# Access Compliance Report

## Public Rights-of-Way

Intersection ID: 10319	Main Street: BACON_AV	Cross Street: ROZZELLES_FERRY_RD	Location: NE
ADA ID: 808B89383699	Ramp Type: PerpDiag	Initial Pass/Fail: Fail	Overall Compliance: No
		Severity Score: 22.5

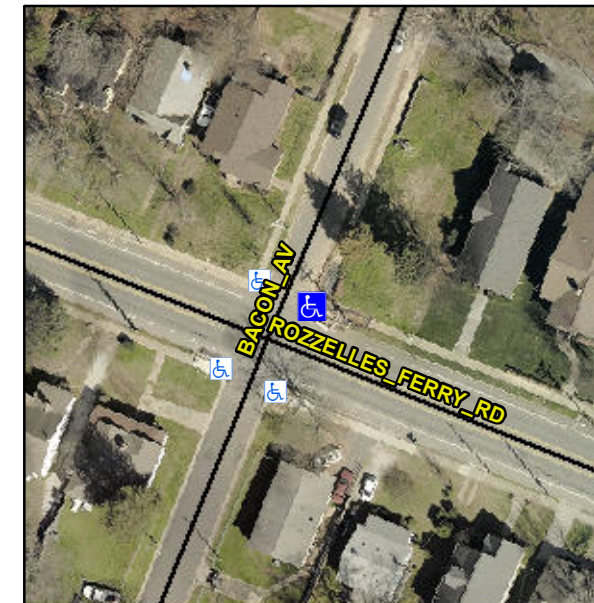
**Not Found, R304.5.1, R304.2.2, R304.5.3**

Compliance	Description	Data	Compliance	Description	Data
N/A	Ramp Length (in)	46.0	No	Ramp Slope (%)	10.1
No	Ramp Width (in)	38.0	No	Ramp XSlope (%)	2.3
N/A	Flare Type LT	N/A	N/A	Flare Type RT	N/A
N/A	Flare Slope LT (%)	N/A	N/A	Flare Slope RT (%)	N/A
N/A	Flare Traversable LT?	N/A	N/A	Flare Traversable RT?	N/A
N/A	Landing Length (in)	N/A	N/A	DWS Provided?	N/A
N/A	Landing Width (in)	N/A	N/A	DWS Contrast?	N/A
N/A	Landing Slope (%)	N/A	N/A	DWS Length (in)	N/A
N/A	Landing X Slope (%)	N/A	N/A	DWS Full Width?	N/A
N/A	Landing Curb? (Y/N)	N/A	N/A	DWS Offset (in)	N/A
N/A	Shared Landing?	N/A			
N/A	Gutter Ponding?	N/A	N/A	Gutter Slope (%)	N/A
N/A	Gutter Lip Ht (in)	N/A	N/A	Gutter X Slope (%)	N/A
N/A	Painted X Walk1?	No	N/A	Painted X Walk2?	No
	X Walk 1 Direction	To NW		X Walk 2 Direction	To SW
N/A	X Walk 1 Width (in)	N/A	N/A	X Walk 2 Width (in)	N/A
	X Walk 1 Slope (%)	0.8		X Walk 2 Slope (%)	10.2
	X Walk 1 X Slope (%)	1.4		X Walk 2 X Slope (%)	1.0

**Remove & Replace Curb Ramp With Two New Directional Ramps or Equivalent.**
